Subject: **Permit Modification Request for the Section 404 Individual Permit, Section 401 Individual Water Quality Certification and CAMA Major Development Permit** for the proposed improvements to US 70 from existing four lanes at Radio Island to north of Olga Road (SR 1426), Carteret County, State Project No. 8.1162501, Federal Aid Project STPNHF-70(43), TIP R-3307, Debit \$570 (NCDWR) and \$100 (NCDCM) from WBS 34528.1.1.

Please see the enclosed revised permit drawings and impact summary sheet for the above referenced project.

R-3307		10
RW SHEET NO.		
ROADWAY DESIGN ENGINEER	HYDRAULICS ENGINEER	
Permit Drawing Sheet 7 of 34 Revised 13 Nov 2015

N.C.D.O.T.
DIVISION OF HIGHWAYS
CARTERET COUNTY
PROJECT: 34528.1.1 (R-3307)
US 70 FROM EXISTING FOUR LANES
AT RADIO ISLAND TO US 70 NORTH
OF SR 1429 (OLGA ROAD)
SHEET (08/SEP/2014)

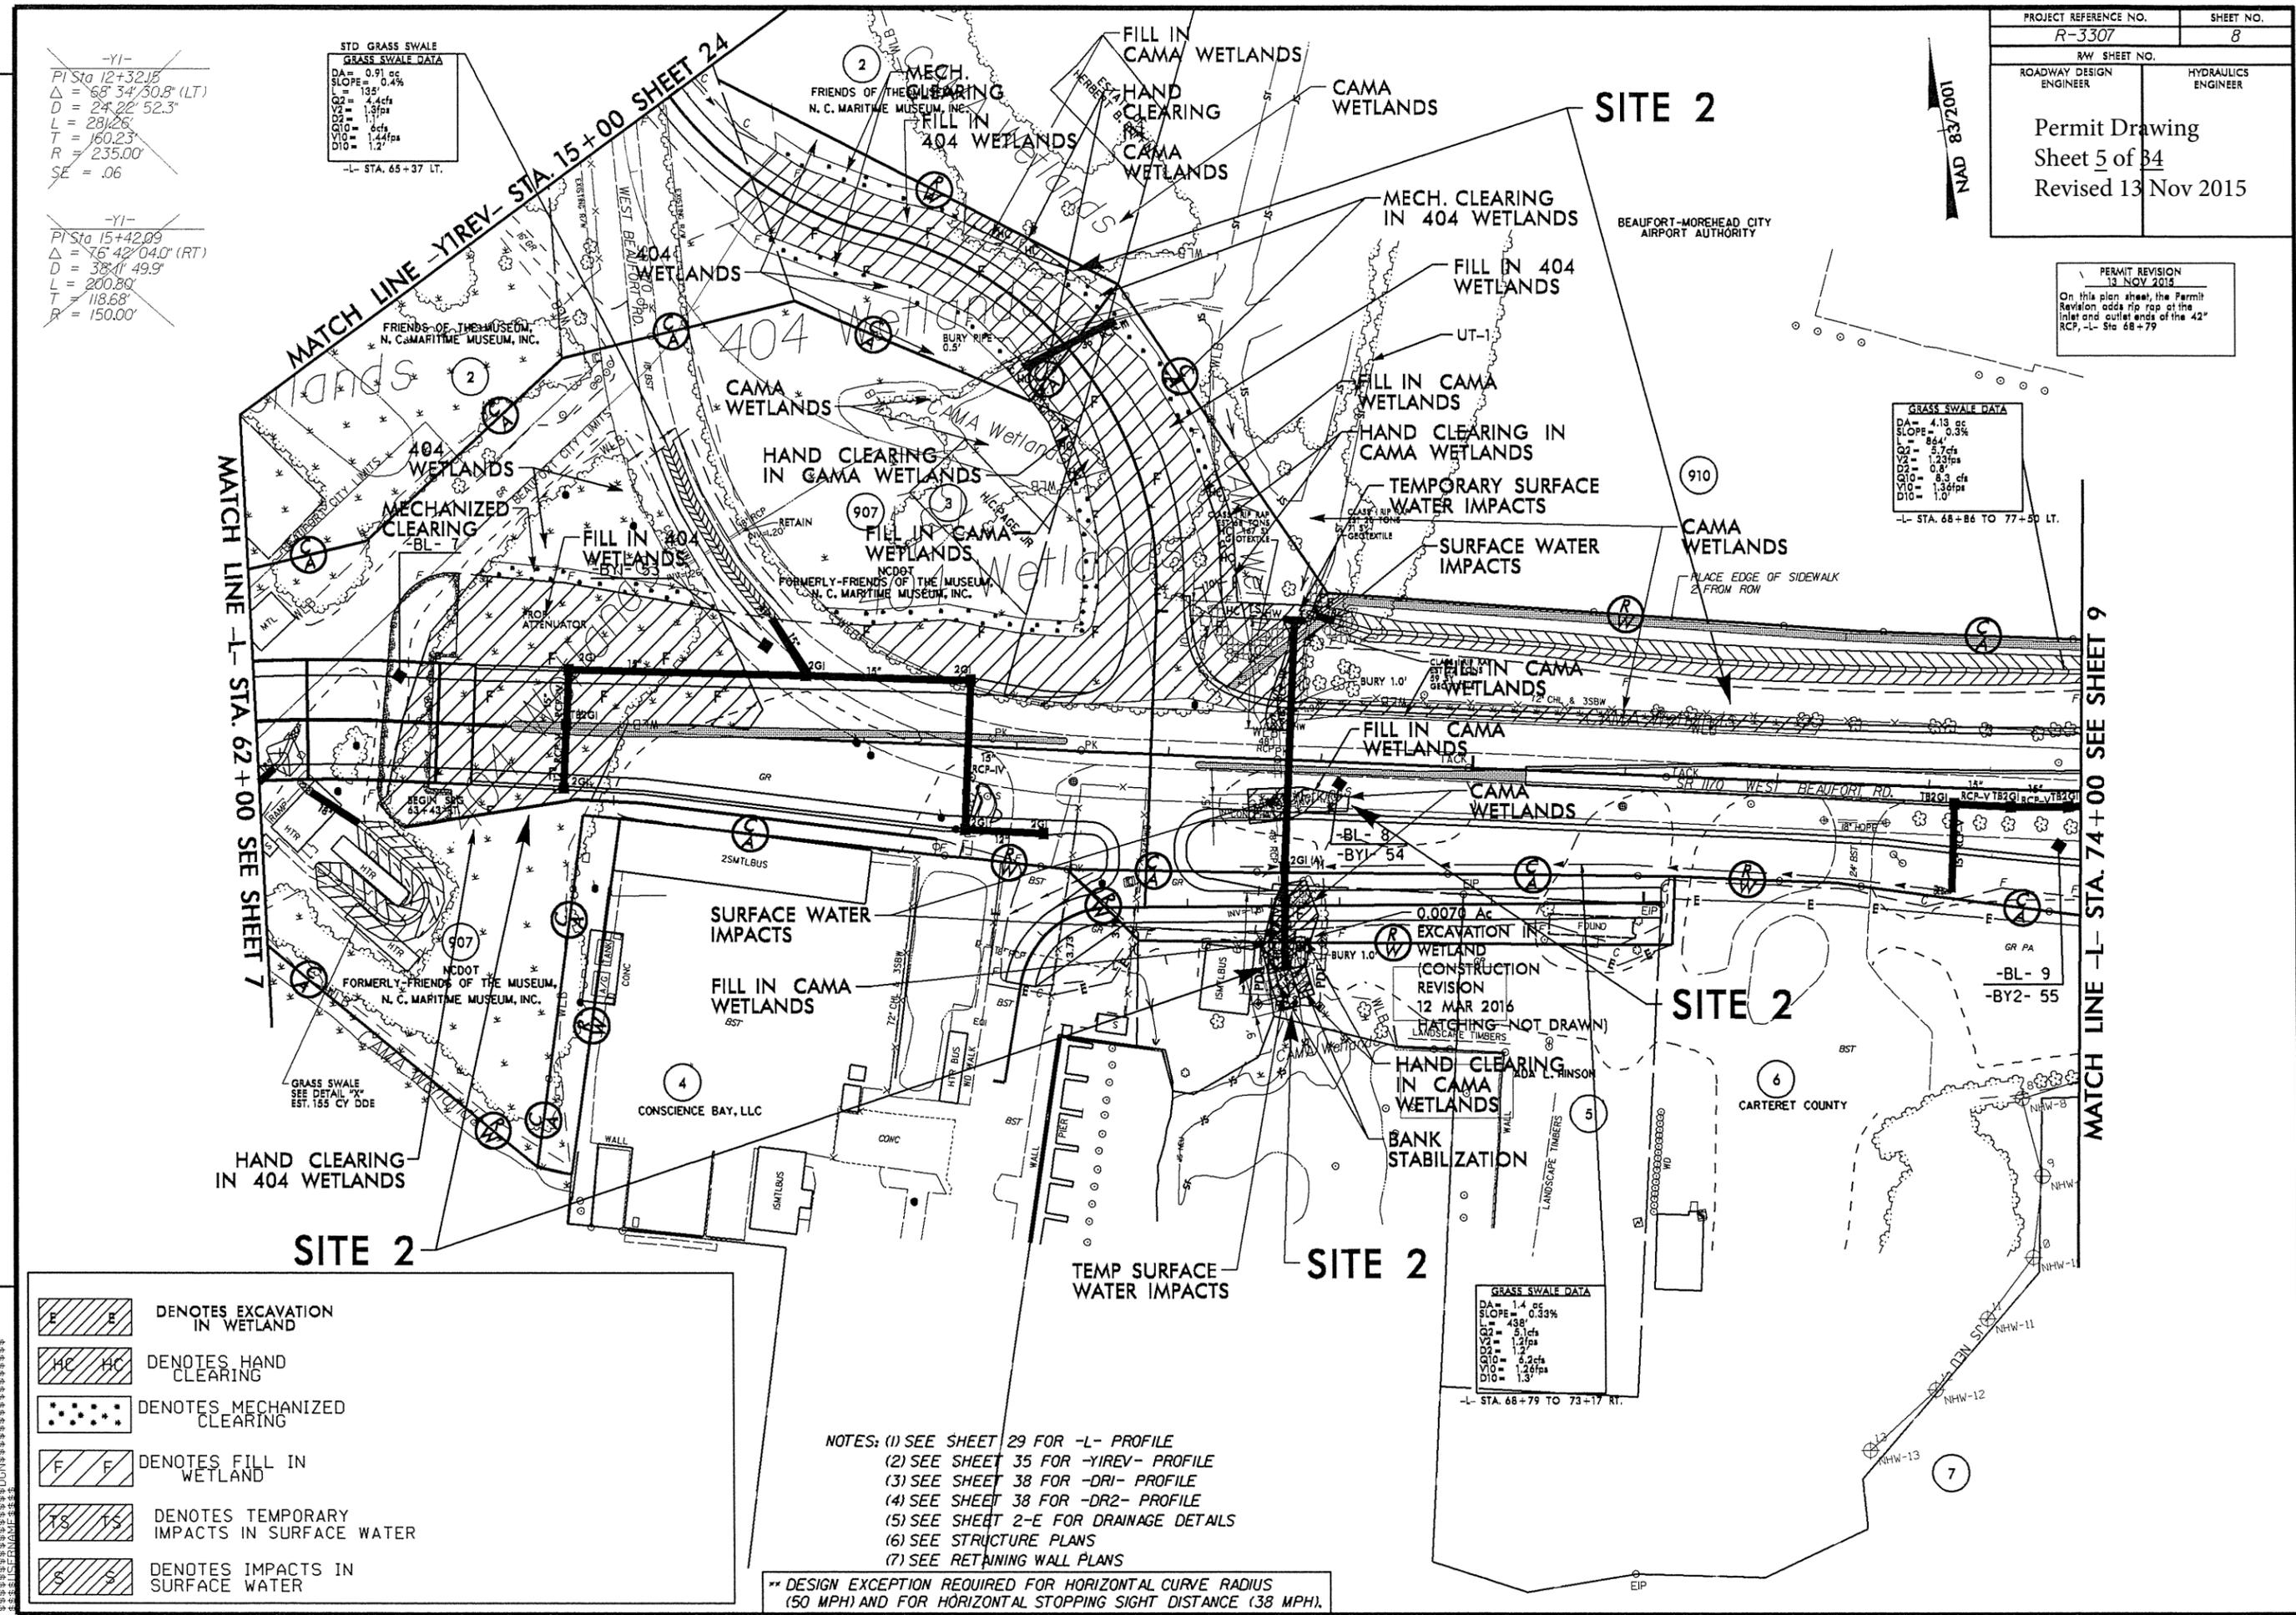
PERMIT REVISION
13 NOV 2015
On this plan sheet, the Permit Revision adds rip rap at the inlet and outlet ends of the 42" RCP, -L- Sta 68+79

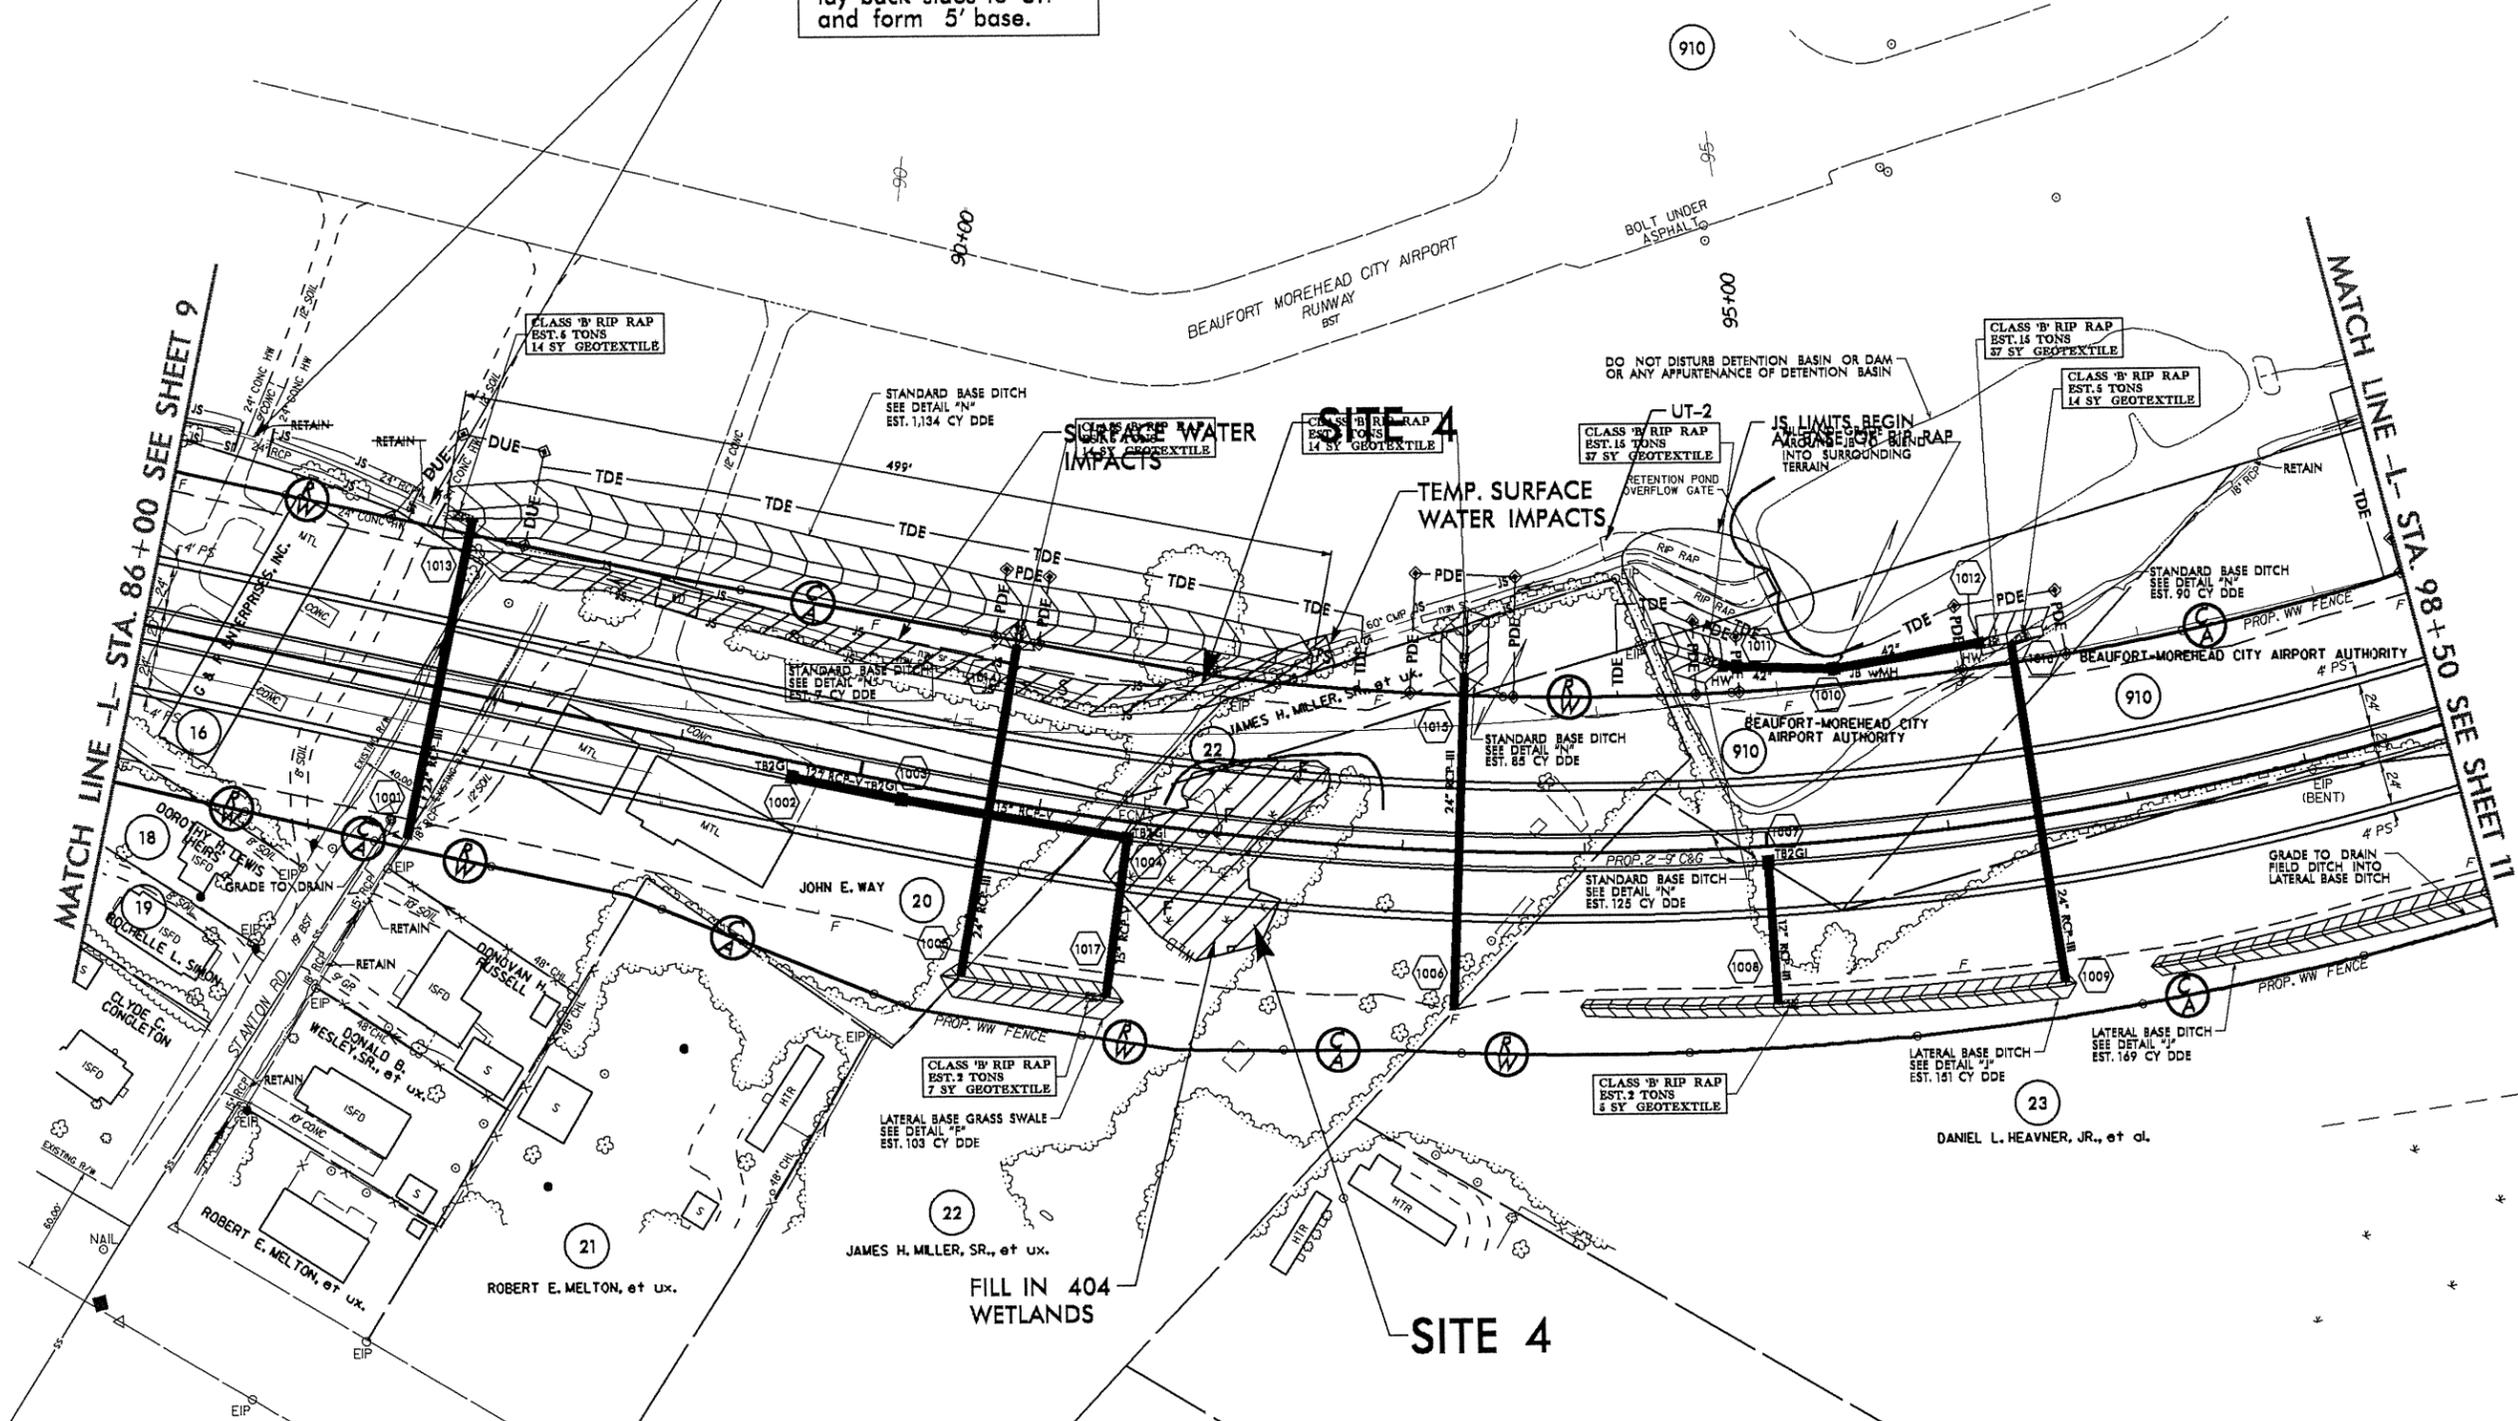
Permit drawing sheets 6 and 7 have been revised to show the removal of small bridges and pipes along a channel adjacent to the Beaufort Morehead City Airport. These will not be replaced.

PERMIT REVISION
13 NOV 2015
Remove bridges & pipe
from channel.
For in-channel work,
lay back sides to 3:1
and form 5' base.
